# UNITED STATES PATENT AND TRADEMARK OFFICE

APPLICATION NO.	FILING DATE	FIRST NAMED INVENTOR	ATTORNEY DOCKET NO.	CONFIRMATION NO.
10/643,661	08/19/2003	William R. Kelley JR.	DKT01053	8203
42595	7590	12/01/2005	EXAMINER	
BORGWARNER INC. PATENT DEPARTMENT 3850 HAMLIN ROAD AUBURN HILLS, MI 48326-2872			RODRIGUEZ, SAUL	
			ART UNIT	PAPER NUMBER
			3681

<b>Office Action Summary</b>	Application No.	Applicant(s)	
	10/643,661	KELLEY ET AL.	
	Examiner	Art Unit	
	Saúl J. Rodriguez	3681

## DETAILED ACTION

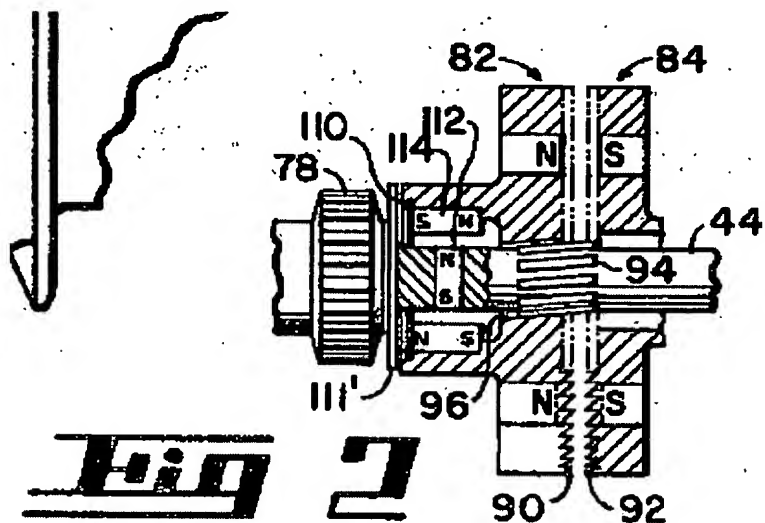
Claims 15, 17-18, 20-23 and, as understood, are rejected under 35 U.S.C. 102(b) as being anticipated by Bird et al. ('064).

Bird discloses a synchronizer and clutch (Fig. 2) comprising a first rotatable member (44) with axially extending engageable teeth (94), a second rotatable member (84) with engageable teeth (92), a clutch collar (87), a plurality of permanent magnets coupled to the second member, an induction member (98), a magnetic spring (102), and a spline between shafts (38, 44).

FIG. -7

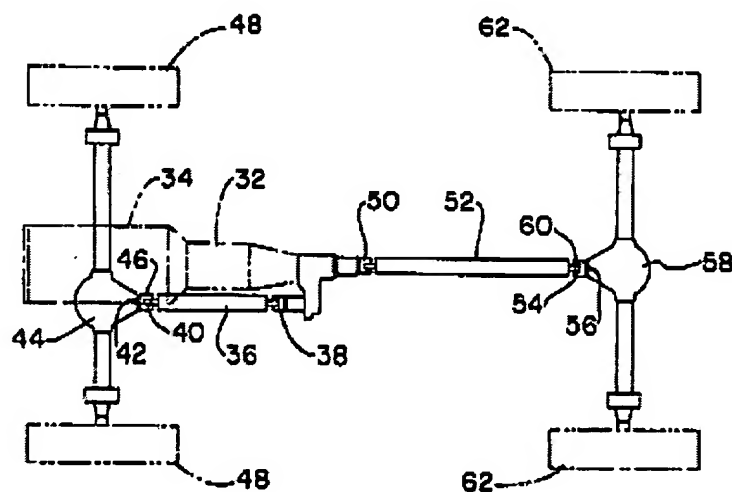
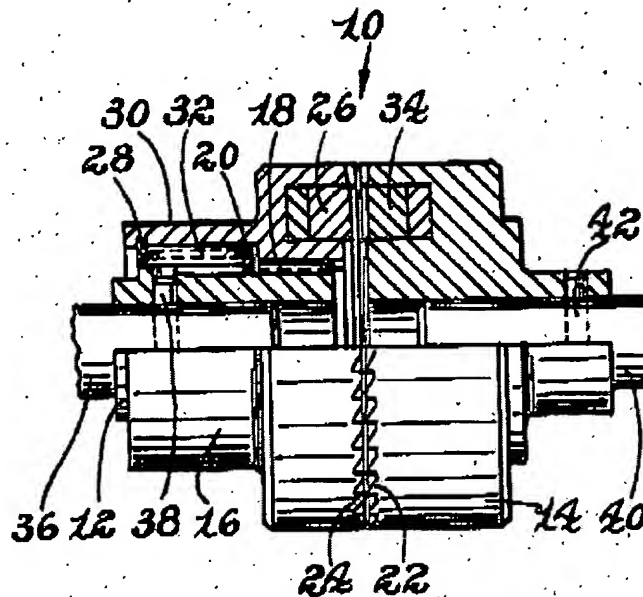
Claim 24, as understood, are rejected under 35 U.S.C. 103(a) as being unpatentable over Bird et al. ('064) in view of Miller ('373).

Bird does shows a magnetic spring instead of a compression spring for controlling the motion of the collar. Miller, on the other hand, discloses what is considered an art recognized equivalent compression spring (32) for controlling the movement of a collar on a magnetically synchronized clutch. Then, it would have been obvious to a person of ordinary skill in the art at the time the invention was made to use a coil spring in the device of Bird in view of Miller to provide if necessary an increasingly larger bias to the collar member.
